3810 Bradley Lane
Cherry Chase

PROJECT: Best Residence

SUBJECT: Historic Area Work Permit #501065--alterations and addition to garage

Staff Item
Anne Fothergill
July 8, 2009
3810 Bradley Lane, Chevy Chase

1
G1.2
Site Plan
SCALE: 1" = 10'

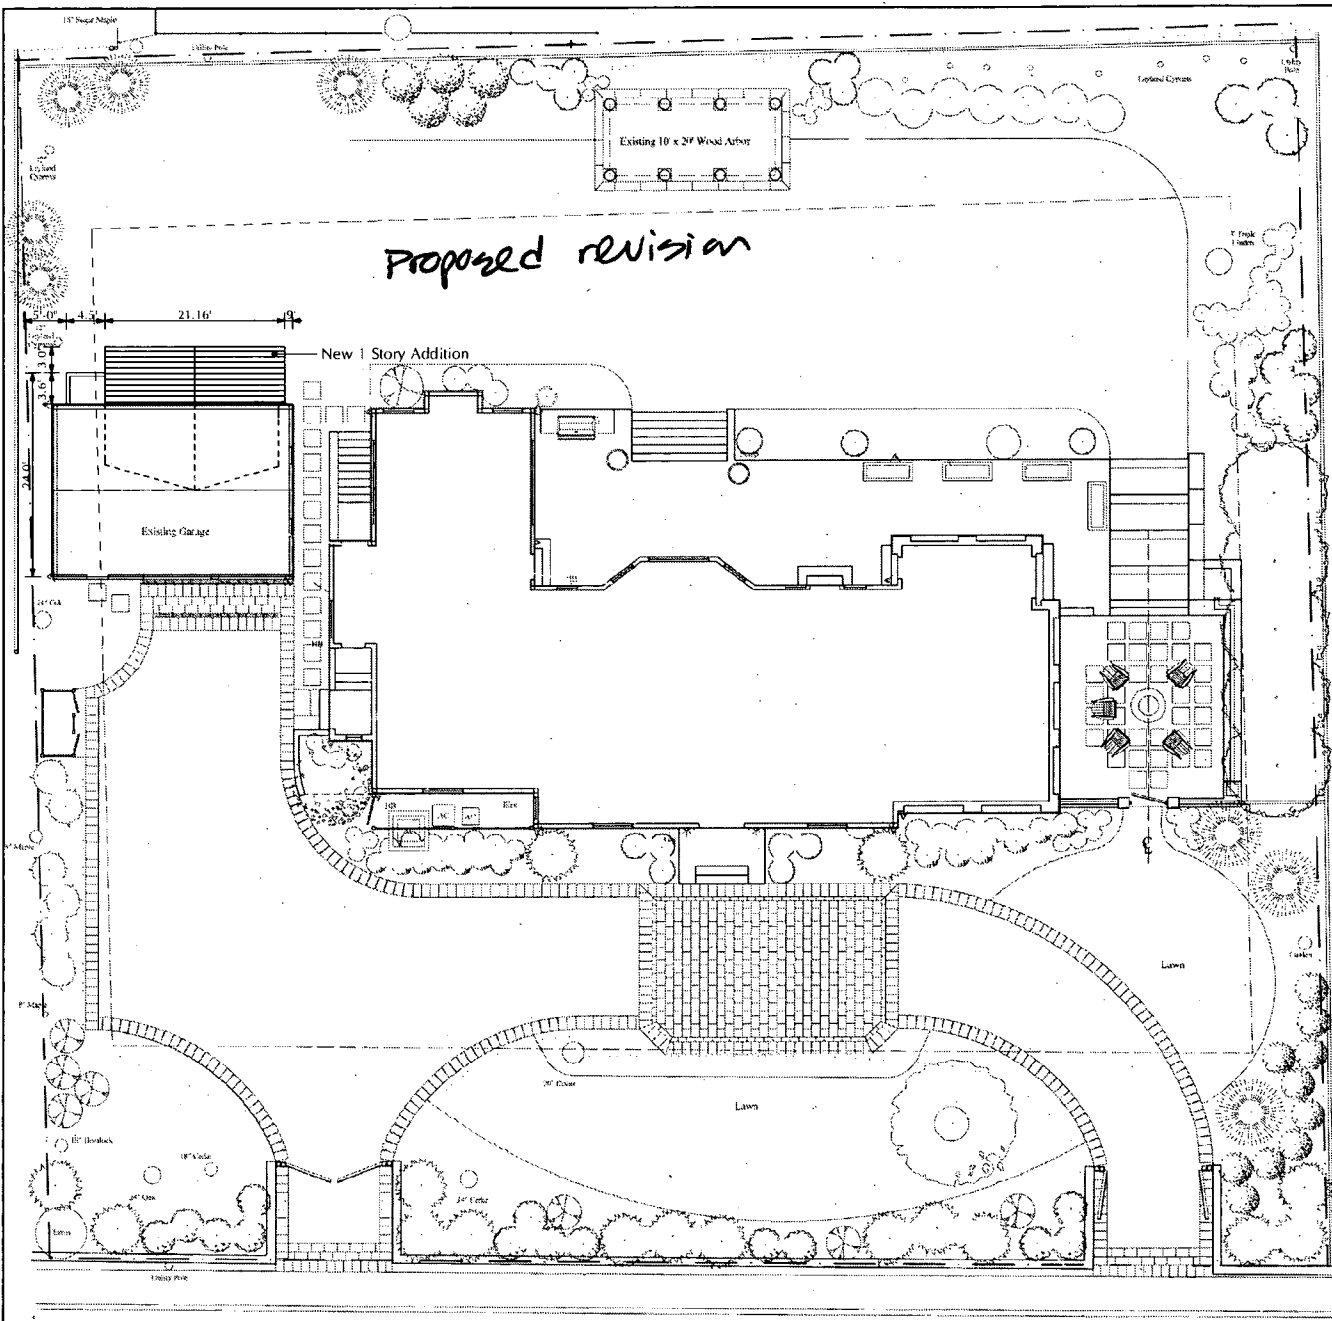
MR. DUFFY: I only have one comment. I don't have any problem with the proposal. I would just request that when you come back with a HAWP, that there be a better site plan. What we have in the pack is very small and it's somewhat difficult to read.

1 East Elevation
SCALE: 1/4" = 1'-0"

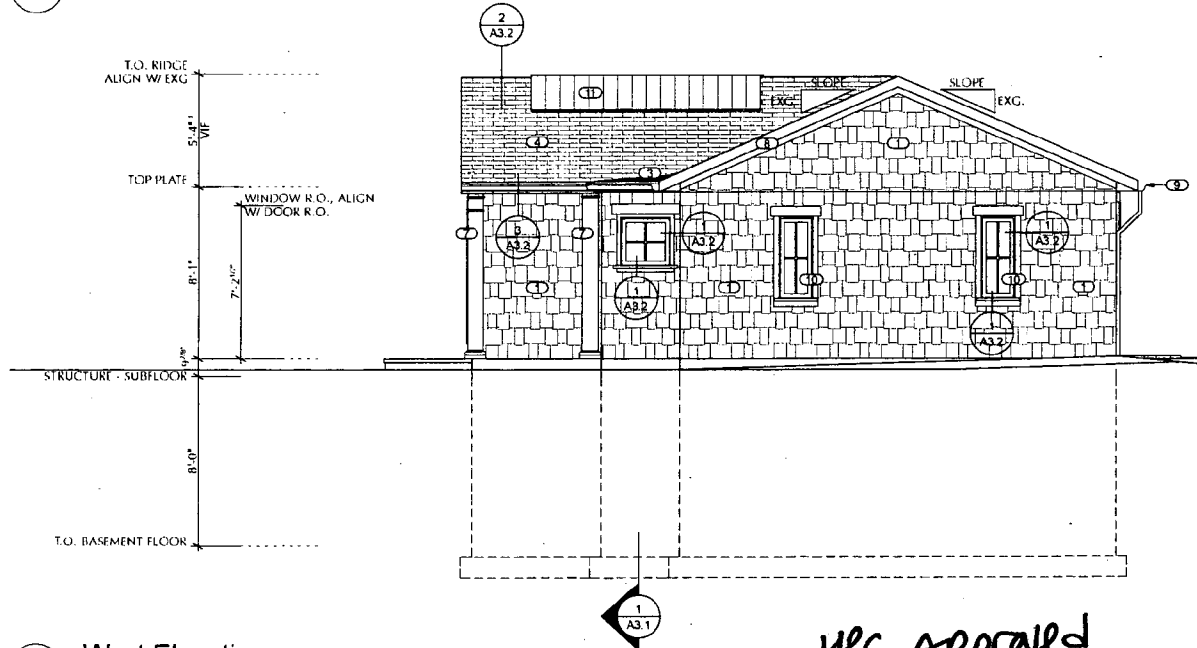
We have made several modifications to the existing approved permit per clients request and would like to have them reviewed by the board:

- 1. Added new dormer at East and West Elevation with standing seam roof and two double casement windows matching the existing house.*
- 2. Eliminated skylight at ridge from the new roof and added new small skylight at shower.*
- 3. Added obscure glass to the shower at North and East Elevation.*
- 4. Added shutters to existing windows at East and West elevation to match existing house.*
- 5. Changed window at rear to 3-unit tilt window with arch top transom.*
- 6. Eliminated entry door at East Elevation and added a double tilt window.*
- 7. New gable addition is 2'-0" shorter and 21'-2" wide. See site plan for reference.*
- 8. New painted cedar trellis with wisteria above garage doors, new side and rear window.*
